**Rehabilitation of the sewers,
the watermain and the
parking lot of the workshop
and rehabilitation of the 15,5
site of the Lachine Canal**

Addendum no 5

Project Number: CLAC-1803

May 8, 2019

CROQUIS
MV-200

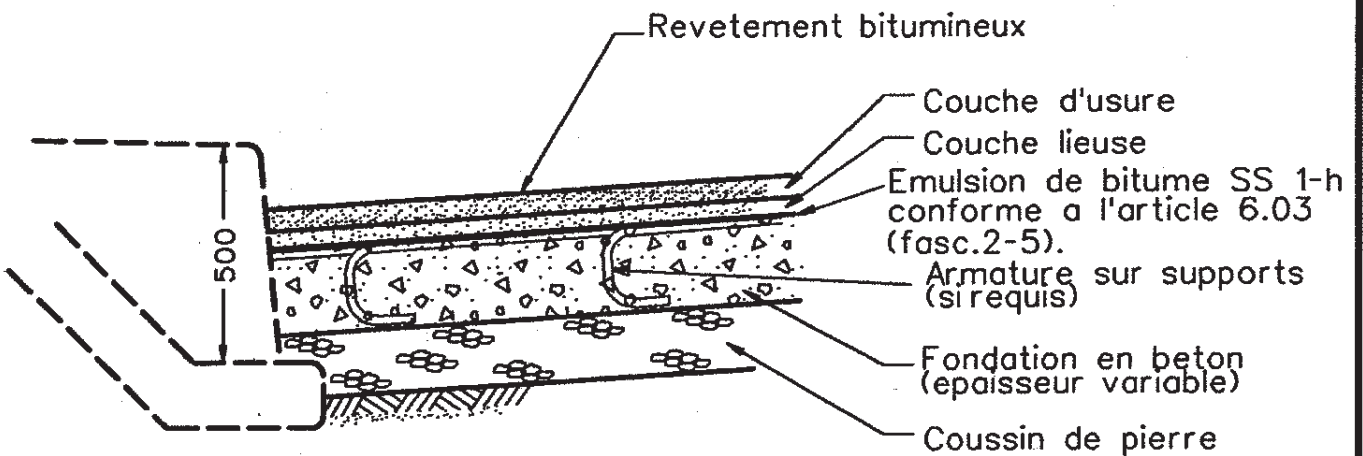
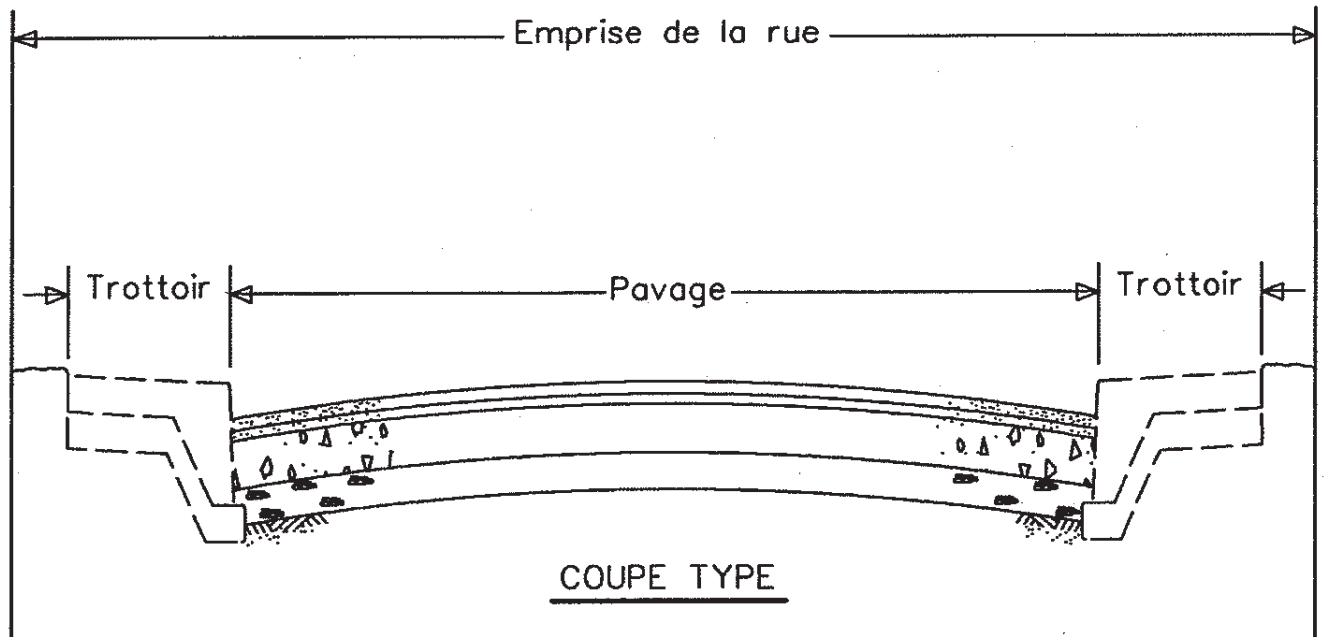
Work on the repair of the Rigid Pavement on Mill Street must be done in accordance with the attached MV-200 Board and comply with the Prescriptions normalisées de la Ville de Montreal (Fascicule 2-5). The concrete slab must have a thickness of 200 mm. The bituminous coatings of the base layer and the wear layer must also comply with the specifications of materials 4VM-10 "Enrobés à chaud" of the Ville de Montreal. All work, materials and thicknesses must be approved and coordinated with the Ville de Montreal.
